Subject: Technical Assistance Request Response
Facility-Wide Site Investigation and Remedial Action Plan
Enbridge Energy Superior Terminal, Superior, Wisconsin
BRRTS # 02-16-560657

SUBJECT: Facility-Wide Site Investigation and Remedial Action Plan
Enbridge Energy Superior Terminal, Superior, WI
WDNR BRRTS Activity #: 02-16-560657

SUBJECT: Technical Assistance Request - Review of Site Investigation and Response Action Plan
Enbridge Energy Superior Terminal (Facility Wide), Superior, WI
WDNR BRRTS Activity #: 02-16-560657

Figure 15

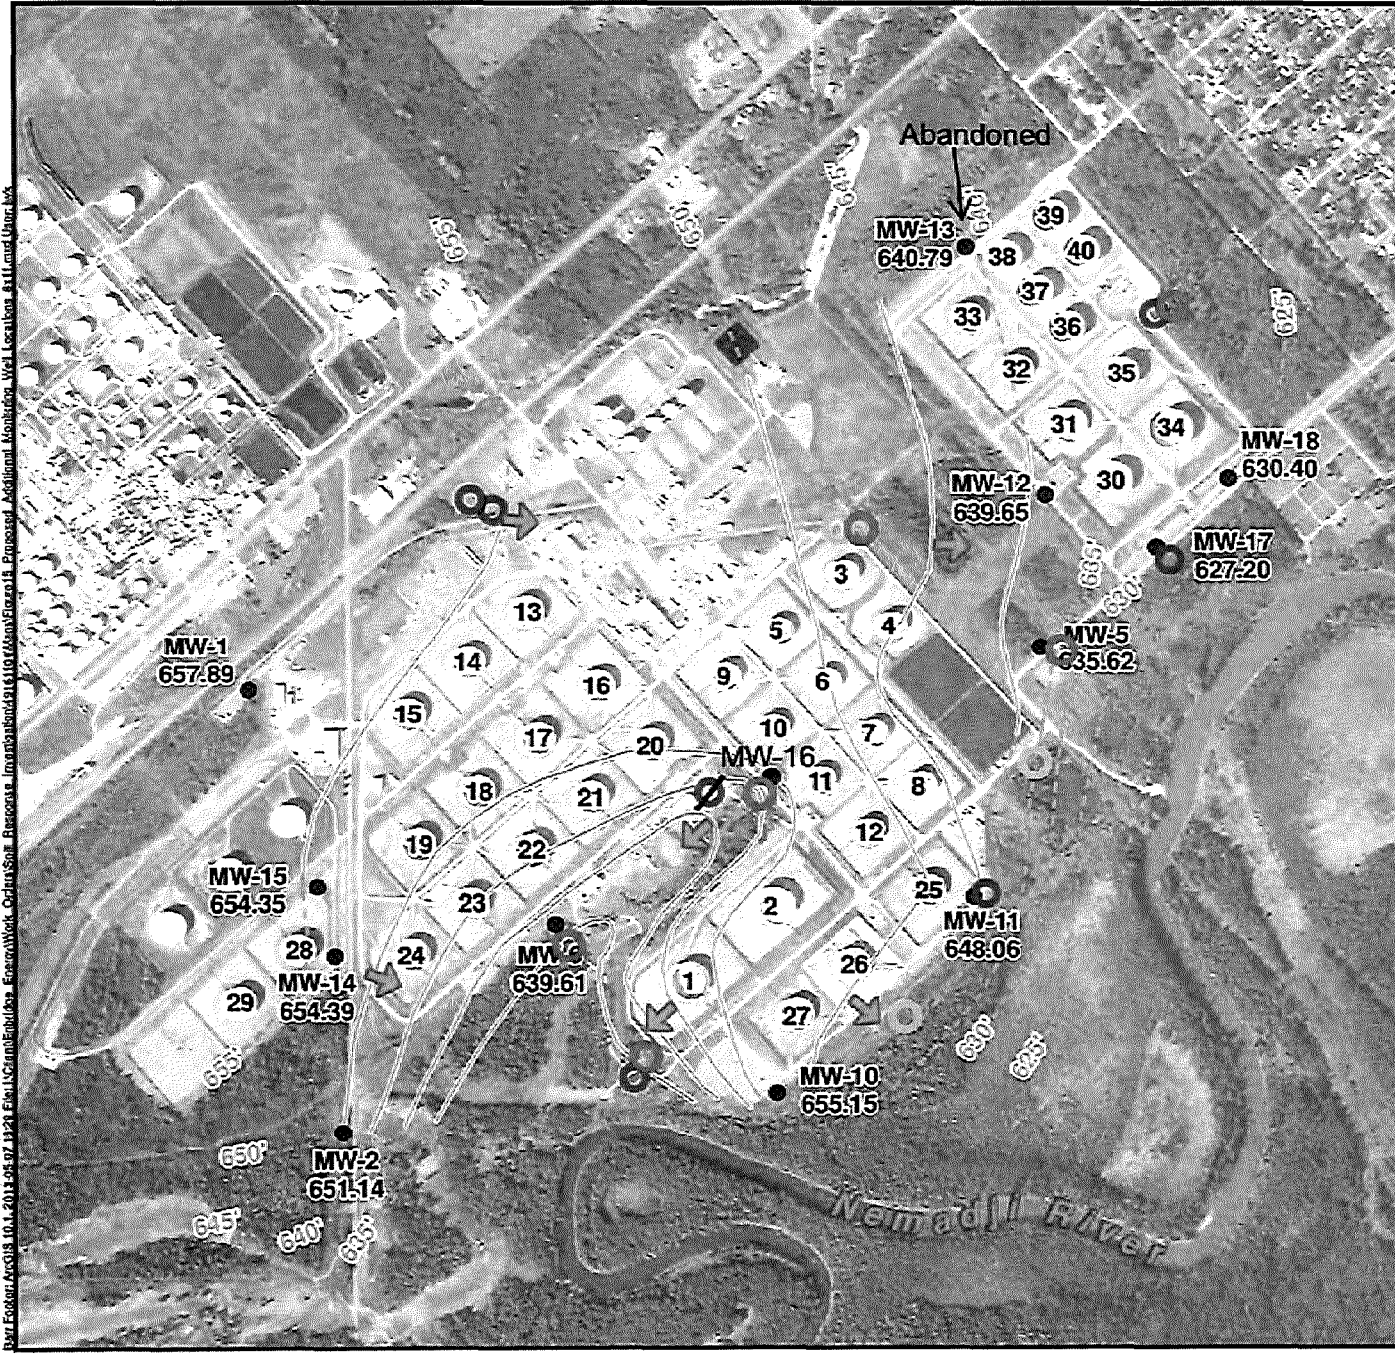
10. The Department approves the groundwater monitoring well network depicted in the attached figure, "Proposed Additional Monitoring Well Locations". We understand some of the wells were installed this year with the remainder of the wells to be installed in 2015. The SI/RAP approval is contingent upon all wells on the attached map being installed and sampled according to the Groundwater Monitoring Plan. Please submit all documentation required under Wis. Admin. Code § NR 141 upon completion of construction of the remaining wells. *In Section 2.1 of the September 2017 Addendum to SI/RAP it is stated three (3) water table wells (MW-24A, MW-25A and MW-26) and six (6) deep piezometer (MW-5B, MW-6B, MW-22B, MW-23B, MW-24B and MW-25B) were installed as part of the Facility-Wide monitoring network.*

10. The Department approves the groundwater monitoring well network depicted in the attached figure, "Proposed Additional Monitoring Well Locations". We understand some of the wells were installed this year with the remainder of the wells to be installed in 2015. The SI/RAP approval is contingent upon all wells on the attached map being installed and sampled according to the Groundwater Monitoring Plan. Please submit all documentation required under NR141 Wis. Adm. Code for construction of the remaining wells to my attention at the letterhead address.

DNR Revisions

- proposed shallow well
- proposed piezometer
- well not needed
